Dunlin Alpha Decommissioning

Stakeholder Engagement Report

Doc Number:	FBL-DUN-DUNA-FAC-01-RPT-00006-Rev A3	Revision Date:	17 April 2024
Rev No:	A3	Revision Status:	For use
Revision Description:	Second post-statutory and public consultation update		
Next Review Date:	Post-OSPAR Review		
Originator:	Carol Barbone	Checked by:	Caroline Laurenson
Date:	17 April 2024	Date:	17 April 2024
Signature:	CAB <i>Carol Barbone</i>	Signature	CL <i>Caroline Laurenson</i>
Approvals			
Title	Name	Date	Signature
Regulatory Affairs & Stakeholder Engagement Manager	Peter Lee	17 April 2024	Peter Lee PL <i>Peter Lee</i>

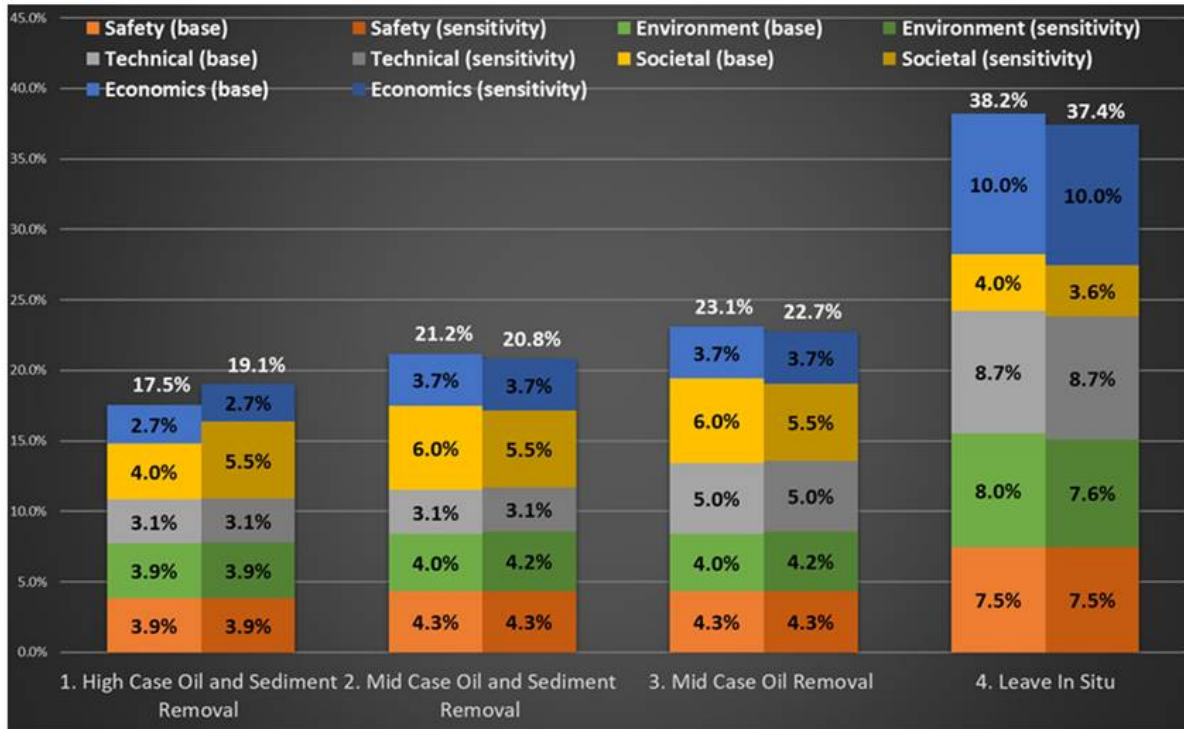
Greenpeace Research Laboratories: (2) I see what is being said here, but I feel that is an artefact of the method...if it is a positive to remove something under one scenario, then the same positive rating should apply if that thing was not there to be removed in the first place. As it stands, it seems that the fact that there is no longer this improvement to be made has counted against that option. In other words, assuming there are no cuttings has pushed one criterion up and another simultaneously down. That seems like a bias. I would be interested to know how the assessment would look if that neutral rating was not applied to offset but instead it was left as a positive, given that the legacy impacts would be expected to be the same for there being no cuttings as there would be in the case that cuttings were there initially but were removed. Otherwise it feels as though Option 1 is in a no-win scenario in relation to this aspect.

Fairfield: As stated earlier, the sensitivity analysis portrayed in section 6.4.2 was based on disregarding the drill cuttings in the evaluation of cell content management options. This sensitivity was conducted to better understand whether the best long term management option for the cells was dependent or independent of the presence of the drill cuttings. With drill cuttings disregarded, the relative merits of each option will naturally change. It would be inappropriate to only disregard the cuttings when it favours a particular option. Put in simple terms, keeping the virtues while ignoring the disadvantages of a single option would seem like the very definition of bias. Building on your point regarding a positive to remove something staying a positive if that thing is not there to be removed in the first place, why would that positive (ie no cuttings present) only apply to option 1? Options 2, 3 and 4 could also lay claim to this positive, if somewhat fictitious, assumption. As a result, the comparative assessment of the options on this aspect would rightly be neutral – just as we concluded in the sensitivity analysis.

That said, your comments made us reflect on why there was any discernible improvement in option 1 under the environmental criterion for the ‘no drill cuttings’ sensitivity. While the wording in table 6.4 accurately reflects the sensitivity case we performed and describes how the two environmental sub-criteria offset one another, and how the societal evaluation of option 1 improved as a result of not bringing large volumes of drill cuttings ashore for processing, we have realised that the bar chart actually portrays the set of assumptions you have proposed. For clarity, the stacked bar chart which shows the environmental evaluation increasing from 3.9% to 4.3% is already based upon the following inputs:

As outlined above, we believe that the above suite of assumptions is demonstrably biased in favour of option 1. As the text and chart are not precisely aligned, we propose to revise the Comparative Assessment Report to include the bar chart which should have been presented in table 6.4. This will show that the environmental evaluation for option 1 was unchanged under the ‘no drill cuttings’ sensitivity analysis, with the only difference in the overall assessment being from the societal benefit of no longer handling the drill cuttings waste stream. We have included the correct chart below and apologise for the error in the original report. In summary, we would contend that the long term management option for the Dunlin cells is insensitive to any assumptions on the presence or management of the drill cuttings.
